Item 4
JRPP 2014SYW090
DA0180/14
870-898 Pacific Highway
Gordon
Council Assessment
Report

**JOINT REGIONAL PLANNING PANEL
(Sydney West Region)**

JRPP No	2014SYW090
DA Number	0180/14
Local Government Area	Ku-ring-gai Council
Proposed Development	Demolish existing structures and construct a mixed use development containing 3 buildings, 144 residential apartments, retail space, basement parking and landscaping works
Street Address	870-898 Pacific Highway, Gordon
Applicant	Alto Prestige Pty Ltd
Owner	Alto Prestige Pty Ltd Georgio Altomonte Holdings Pty Ltd
Number of Submissions	Original proposal – 3 submissions Amended proposal – 1 submission Further amended proposal – 1 submission
Recommendation	Refusal
Report by	Grant Walsh, Executive Assessment Officer

Figure 2.0 – Source – Clause 4.6 prepared by Ryan Planning, dated July 2015

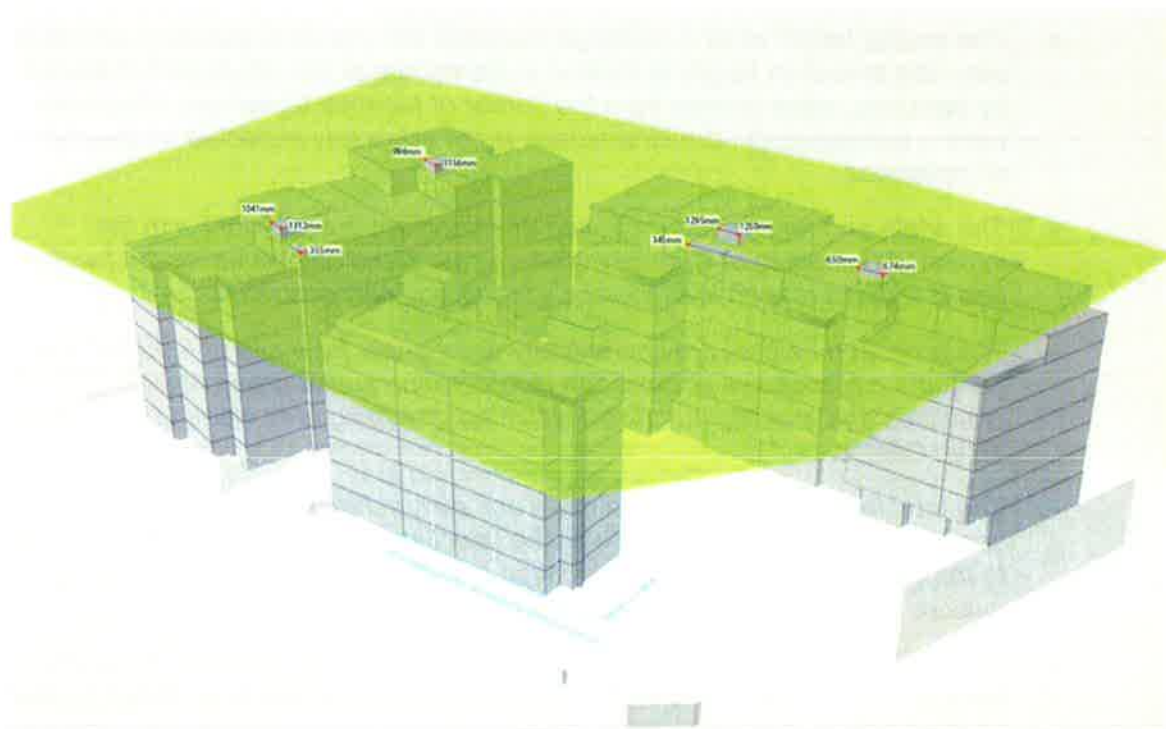
It is noted that there are no discernible impacts that arise as a result of these height breaches (above the interpolated ground line or the height plane as defined by the LEP). The reasons/justification put forward by the applicant are well founded and are accepted in this case.

Figure 1: View from the sun 12pm June 21

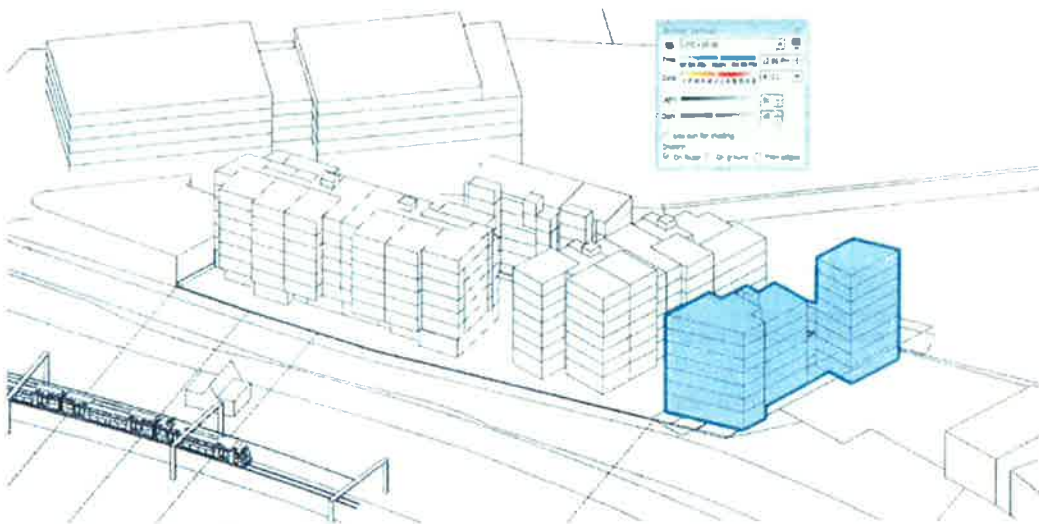
Referring to Figure 1, I note in particular the overshadowing of the lower three floors of Building A. It is self-evident that as the afternoon progresses that overshadowing will become worse.
